Appl. No. 10/752,402
Response to OA dated March 5, 2007
Amendment dated April 26, 2007

PATENT
Docket No. 13067-004001
(J-CN4001)

Amendments to the Drawings

Applicant: Charles Nelson
 - Docket No.: 13067-004001
 Title: "Venting Reclosable Bags"
 Fig. 1
 Sheet 1 of 1 (Replacement Sheet)

FIG. 1

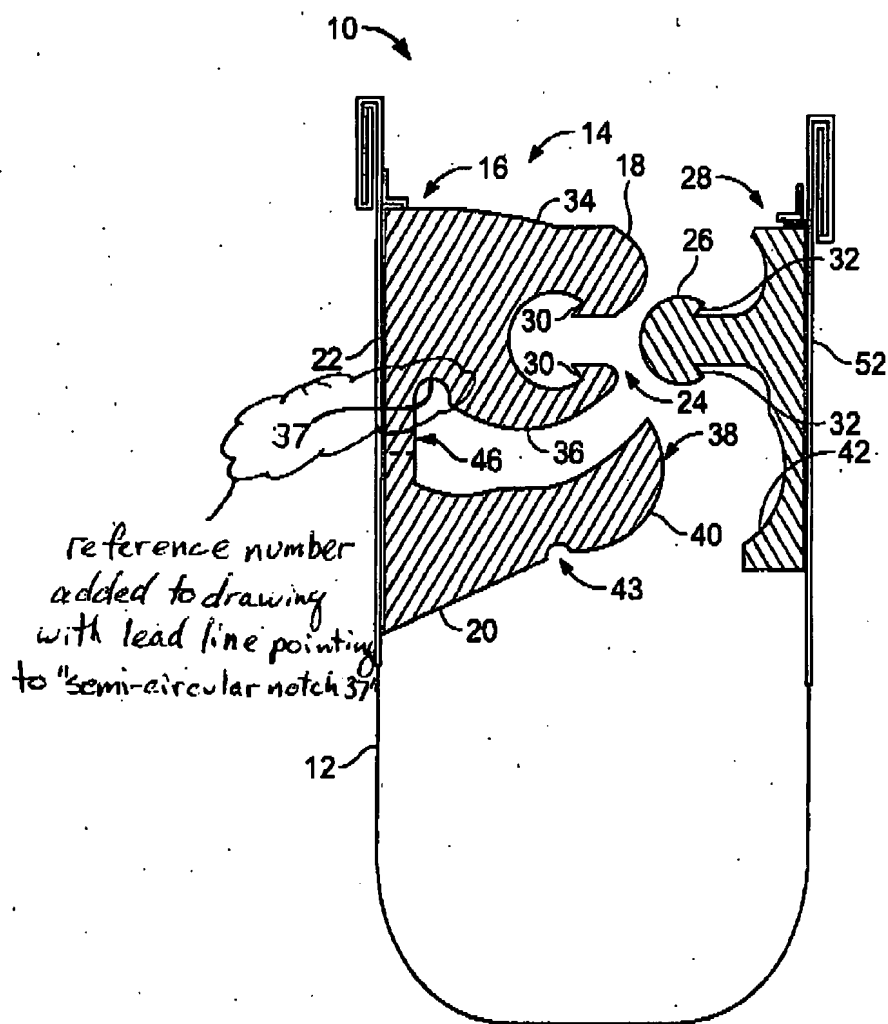
FIG. 1 has been amended to include reference number 37 and an appropriate lead line to the "semi-circular notch 37" at the base of the "inboard arm 36," as described in detail at page 6, line 27 of the specification . No new matter is presented hereby.
